Lee Nuclear Station Units 1 and 2

Evaluation of 2012 Field Investigation Results for Plant Relocation

FIGURE 2.5.2-244a

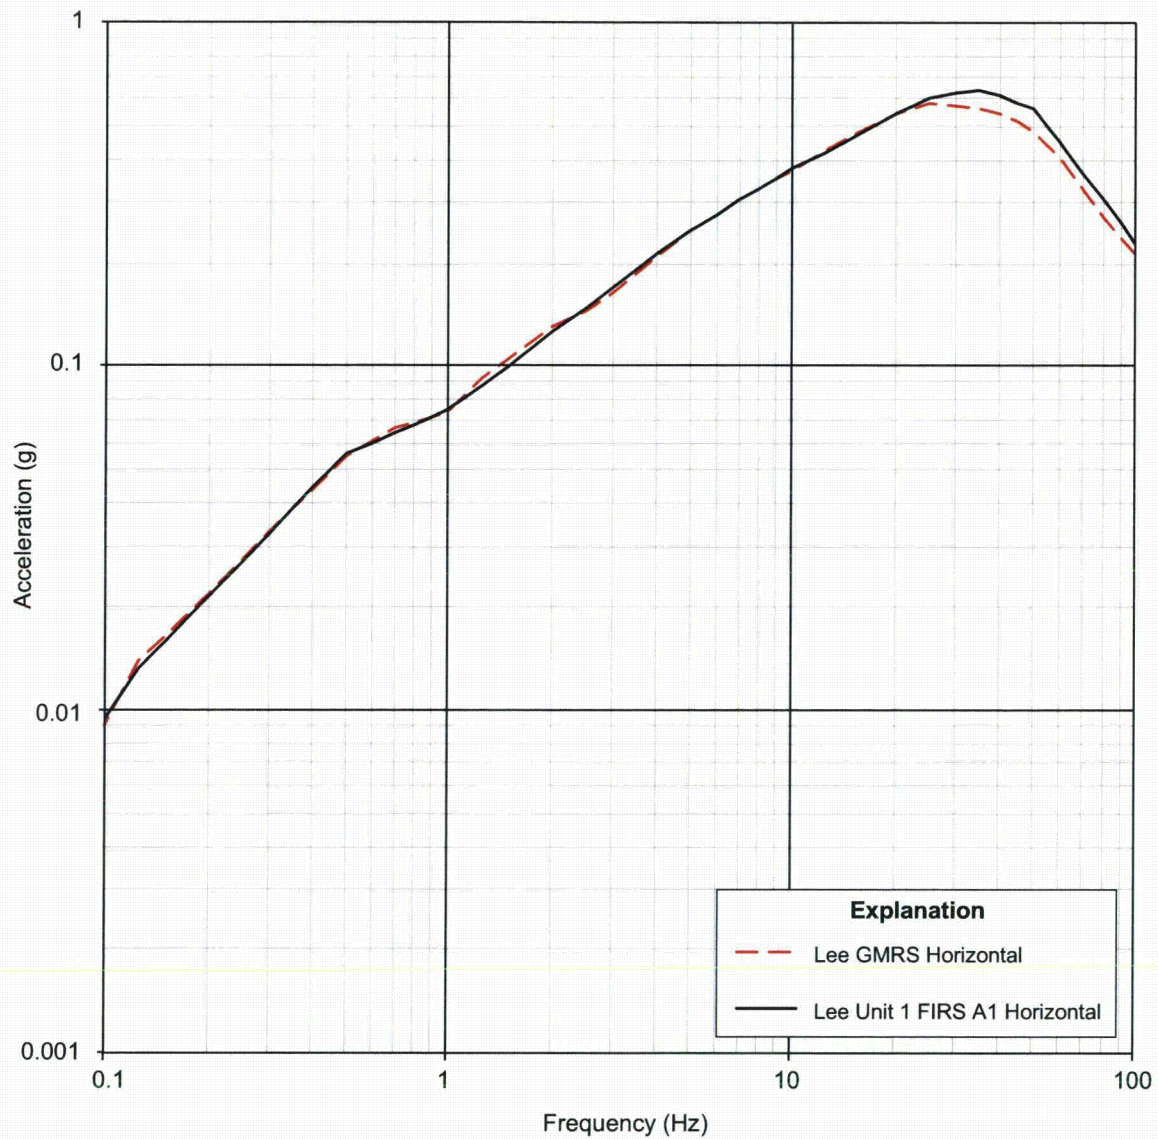
27. COLA Part 2, FSAR Chapter 2, Figure 2.5.2-244 is deleted and presented as Figure 2.5.2-244a, Figure 2.5.2-244b, and Figure 2.5.2-244c as follows:

28. COLA Part 2, FSAR Chapter 2, Figure 2.5.2-244a is added as follows:

FIGURE 2.5.2-247a

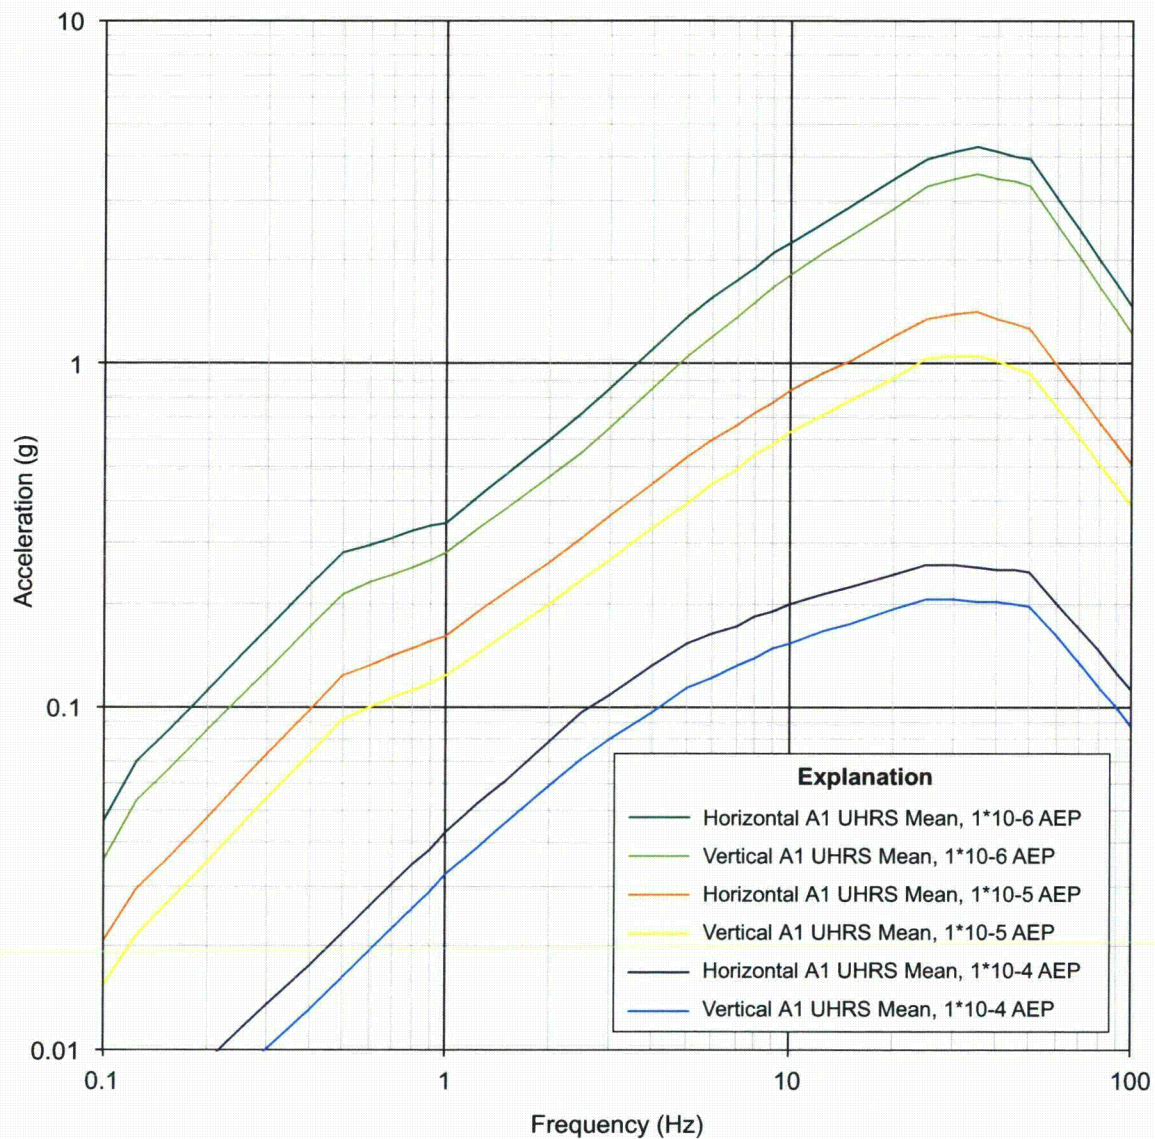
39. COLA Part 2, FSAR Chapter 2, Figure 2.5.2-247 is deleted and presented as Figure 2.5.2-247a, Figure 2.5.2-247b, and Figure 2.5.2-247c as follows:

40. COLA Part 2, FSAR Chapter 2, Figure 2.5.2-247a is added as follows:
